Subject: Part 2 - NRC Submittal
Creation Date: 12/11/2006 6:15:53 PM
From: "Williams, Dana M." <X2DANAWI@southernco.com>

AR-06-2684

45	The section on unavoidable adverse environmental impacts discusses social issues without specificity and never identifies any particular environmental concern. Clarify this discussion to include specific environmental adverse impacts for construction and operations, including an assessment of the before- and after-mitigation value of those impacts? Include the EJ effects of both construction and operations for each alternative site. Provide a table that displays all of the adverse environmental impacts of construction and operations (including human health effects); a description of each impact; all mitigation strategies to be undertaken by the applicant for that impact, the cost of mitigation, and the expected value of the unavoidable portion of that impact.
----	---

NRC Question 114

Figure 1 – Average daily suspended sediment load for Savannah River at Clio, GA (USGS Gage No. 2198500)

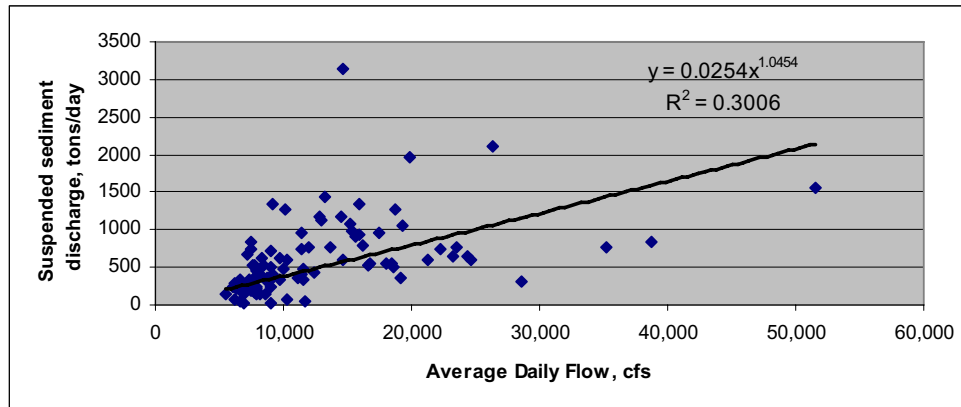
Provide estimated erosion characteristics and sediment transport rates, including bed and suspended load fractions, for the Savannah River near the site.

These data points are listed in Table 2 and are plotted in Figure 1 against the average daily discharge recorded for those days. There is only a slight correlation between average daily discharge in cfs and suspended sediment load in tons per day, so the suspended load data time series can not be extended with much reliability.
